Wyong Shire Council

## **ORDINARY MEETING**

16 June 2011

### **DA/736/2010 – Proposed Residential Flat Building at The Entrance**

Figure 1 - Setback encroachment levels 5 and 6 in tower “B” adjacent to western boundary

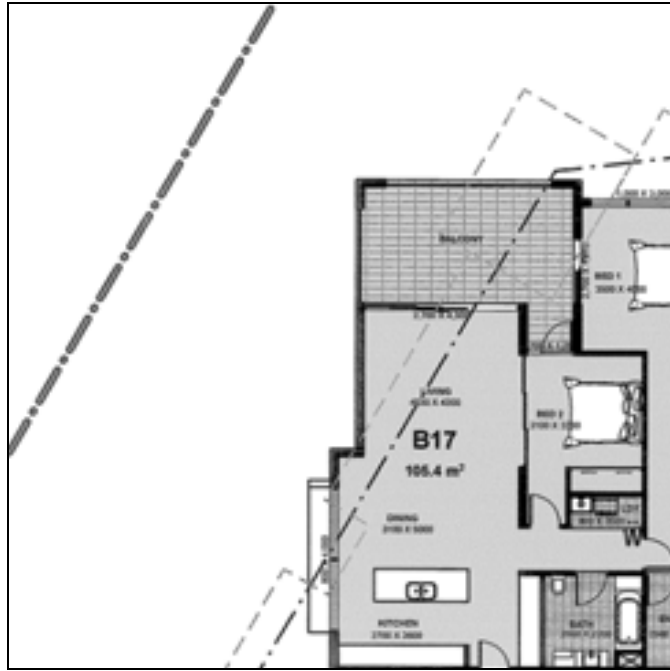
Levels 5 and 6 in towers A and B encroach into the nominal side setbacks required under Chapter 64 development guidelines. The required standard is 9 metres from the boundary to

the face of the building (including a balcony). The encroachment includes open balcony space and part of the floor space of the units. For the most part the intrusions are merely part of the above mentioned components – i.e., part of the balcony or part of the unit floor area.

The portion of tower “B” that encroaches adjacent to the western and southern boundaries (see figures 1 and 2) involves mainly an open level balcony and is not considered to adversely impact on amenity by way of restricting solar access or increased noise problems.

Figure 3 - Setback encroachment levels 5 and 6 in tower "A" adjacent to northern boundary

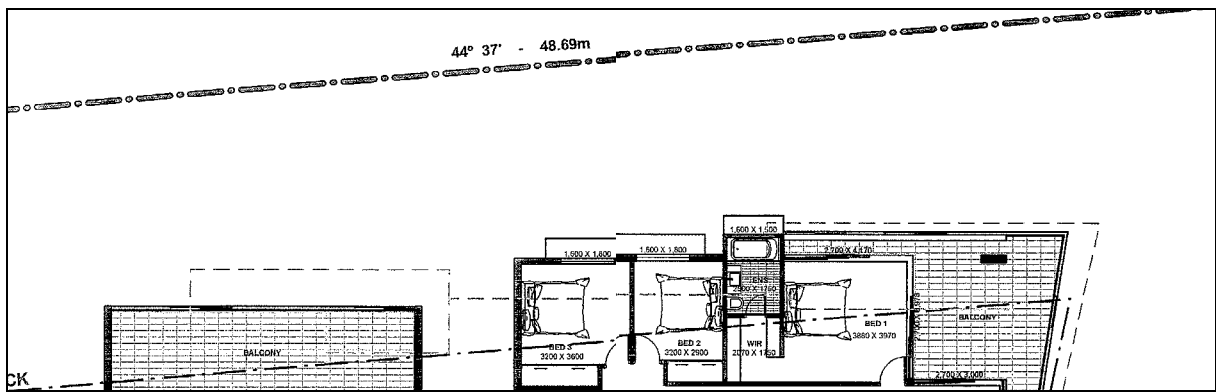
The portion of tower “A” that encroaches adjacent to the northern boundary (see figure 3) involves an open level balconies and bedrooms. This part of tower “A” is on the southern side of the neighbouring residence and is not considered to adversely impact amenity by way of restricting solar access or increase noise problems.
